Microcontroller Technical Information

QB-78K0KX2 In-Circuit Emulator for 78K0/KB2, 78K0/KC2, 78K0/KD2, 78K0/KE2, 78K0/KF2 Usage Restrictions		Document No.	ZBG-CD-07-0062	1/2
		Date issued	September 6, 2007	
		Issued by	Development Tool Solution Group Multipurpose Microcomputer Systems Division Microcomputer Operations Unit NEC Electronics Corporation	
Related documents	QB-78K0KX2 User's Manual: U17341EJ5V0UM00	Notification classification	√	Usage restriction Upgrade Document modification Other notification

No. 7 Restrictions on power-on-clear (POC) function

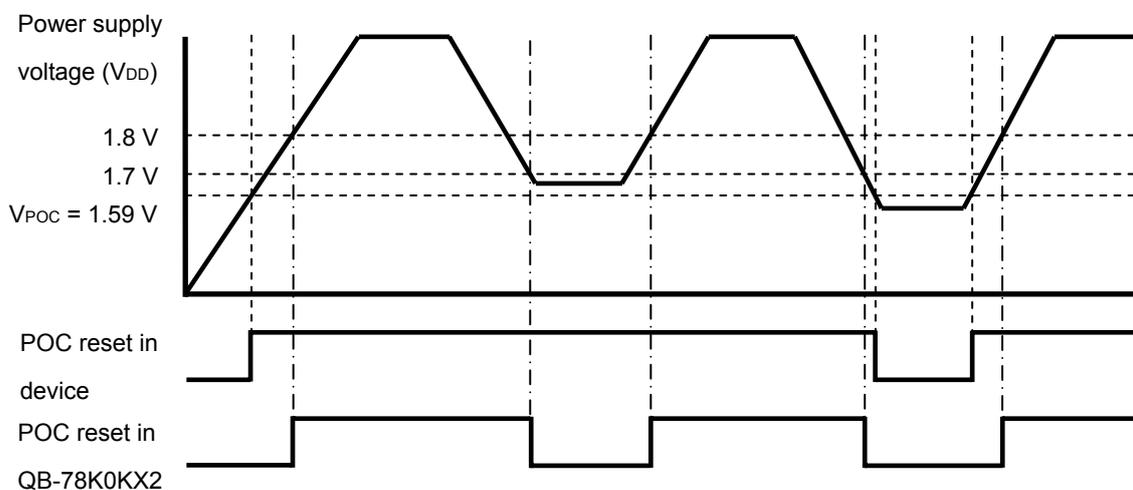
The POC detection voltage differs between the QB-78K0KX2 and the device.

(1) In 1.59 V POC mode (option byte: POCMODE = 0)

- Device:** An internal reset signal is generated at power application, and the reset state is released when the power supply voltage (V_{DD}) exceeds the detection voltage ($V_{POC} = 1.59\text{ V} \pm 0.15\text{ V}$).

The power supply voltage (V_{DD}) and detection voltage ($V_{POC} = 1.59\text{ V} \pm 0.15\text{ V}$) are compared, an internal reset signal is generated when V_{DD} drops lower than V_{POC} ($V_{DD} < V_{POC}$), and the reset state is released when V_{DD} becomes V_{POC} or higher ($V_{DD} \geq V_{POC}$).
- QB-78K0KX2:** An internal reset signal is generated at power application, and the reset state is released when the power supply voltage (V_{DD}) exceeds 1.80 V.

An internal reset signal is generated when V_{DD} drops lower than 1.70 V ($V_{DD} < 1.70\text{ V}$), and the reset state is released when V_{DD} becomes 1.80 V or higher ($V_{DD} \geq 1.80\text{ V}$).

There is no workaround. Regard this issue as a permanent restriction.

(2) In 2.7 V/1.59 V POC mode (option byte: POCMODE = 1)

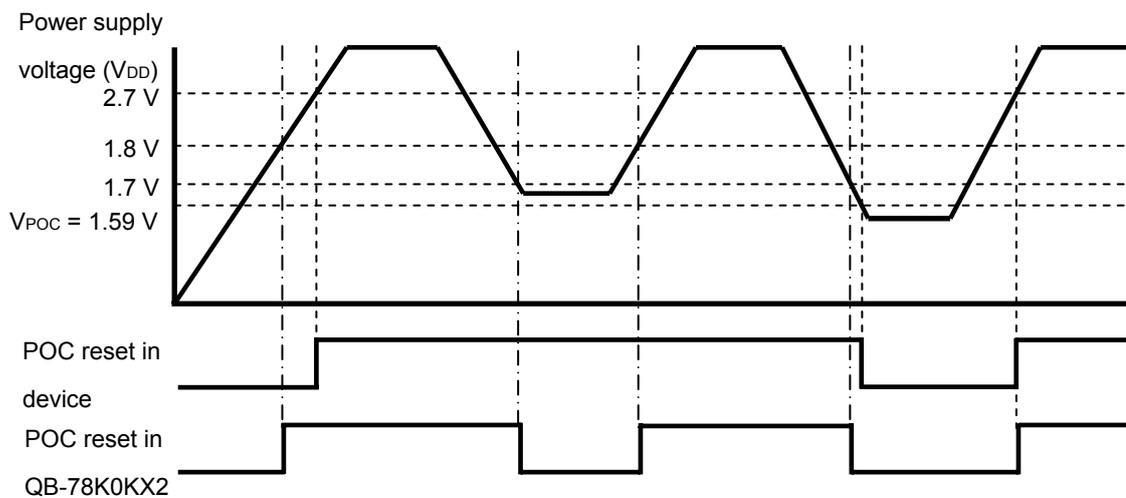
- Device:** An internal reset signal is generated at power application, and the reset state is released when the power supply voltage (V_{DD}) exceeds V_{POC} (power detection voltage at power application; $V_{POC} = 2.7\text{ V} \pm 0.2\text{ V}$).

The power supply voltage (V_{DD}) and detection voltage ($V_{POC} = 1.59\text{ V} \pm 0.15\text{ V}$) are compared, an internal reset signal is generated when V_{DD} drops lower than V_{POC} ($V_{DD} < V_{POC}$), and the reset state is released when V_{DD} becomes 2.7 V or higher ($V_{DD} \geq 2.7\text{ V}$).

- QB-78K0KX2: An internal reset signal is generated at power application, and the reset state is released when the power supply voltage (V_{DD}) exceeds 1.80 V.

An internal reset signal is generated when the detection voltage ($V_{POC} = 1.59\text{ V} \pm 0.15\text{ V}$) < V_{DD} < 1.70 V, and the reset state is released when V_{DD} becomes 1.80 V or higher ($V_{DD} \geq 1.80\text{ V}$).

If the power supply voltage (V_{DD}) drops to a level of the detection voltage ($V_{POC} = 1.59\text{ V} \pm 0.15\text{ V}$), the reset state is released the next time the power supply voltage (V_{DD}) exceeds V_{POC} (power detection voltage at power application; $V_{POC} = 2.7\text{ V} \pm 0.2\text{ V}$).

2.5.2 Mounting YQ on NQ on page 26

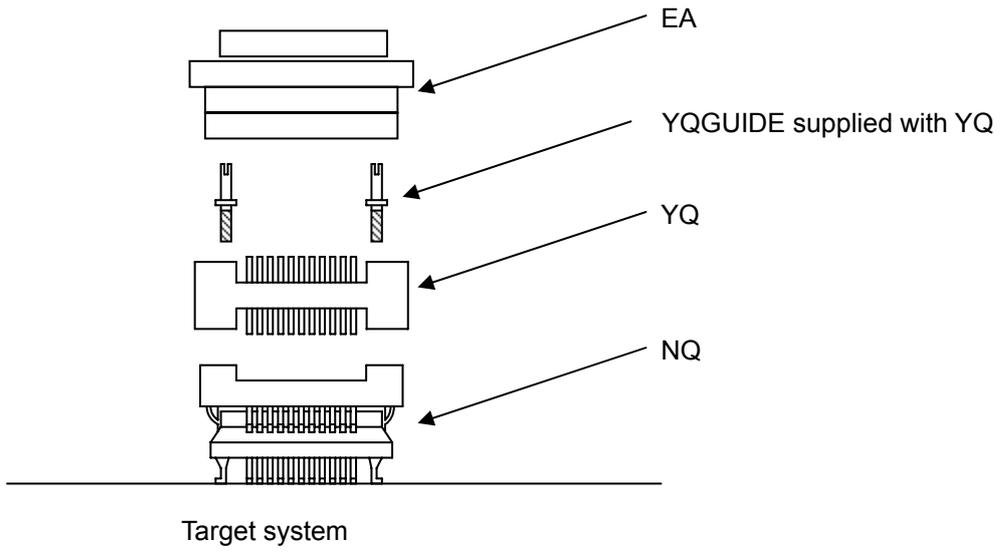
- (1) After confirming that there are no broken or bent YQ contact pins, fit the YQ in the NQ and fasten the screw. If repeatedly inserting and removing, be sure to inspect the YQ pins before fitting. If pins are bent, correct them using something thin and flat such as the edge of a knife.
- (2) Accessory holes are needed in prescribed positions in 4 places in the board for connecting the YQ. Fasten the YQ to the NQ on the user board using the supplied M2 × 10 mm screws. The thickness of a board corresponding to these screws is 1.0 to 2.0 mm. Fasten the screws equally in the four corners using a No. 1 or No. 0 precision (+) driver or torque driver. The tightening torque of the screws is 0.054 Nm (MAX.). Too great tightening causes bad connections.
Screws for fitting to the NQ (M2 × 10 mm/4) are included with the YQ.

- (1) After confirming that there are no broken or bent YQ contact pins, fit YQ in NQ and fasten it using the supplied YQGUIDE (for the fastening method, see the next step, (2)). If repeatedly inserting and removing, be sure to inspect the YQ pins before fitting. If pins are bent, correct them using something thin and flat such as the edge of a knife.
- (2) Fasten YQ to NQ on the target system using the supplied YQGUIDE. Fasten the screws equally in the four corners using the supplied flat-blade screwdriver or a torque driver. The tightening torque of YQGUIDE is 0.054 Nm (MAX.). Too great tightening causes bad connections.
Four screws for fitting to the MA (M2 × 10 mm / 4 units) are included with YQ.
